H268NAS1

TECHNICAL BULLETIN

Service Action: Startup Battery Cable - Install Retaining Clip

MODEL:	MODEL YEAR:	VIN:	APPLICABILITY:
XE (X760)	2019	487656-487797	V8 S/C 5.0L Petrol

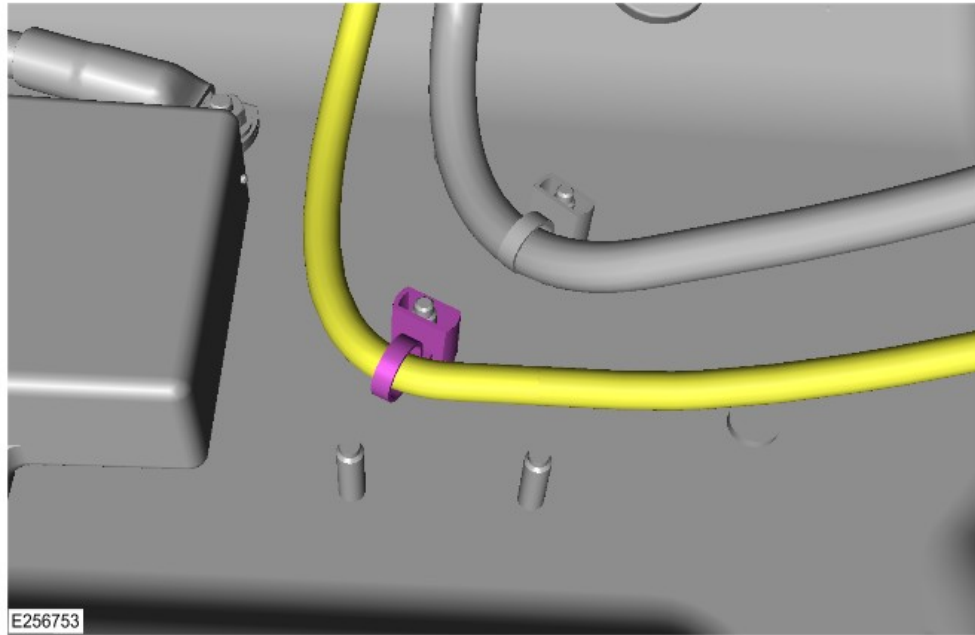
A potential issue has been identified on certain Jaguar vehicles within the listed Affected Vehicle Range have been manufactured without an additional vehicle startup battery cable retaining clip. Without the retaining clip, there is potential for a touch condition between the vehicle startup battery positive cable and a loadspace floor stud.

Install the new retaining clip and secure to the vehicle startup battery positive (+) cable to the loadspace floor stud as shown.

Make sure the excess cable tie is removed at the base of the retaining clip.
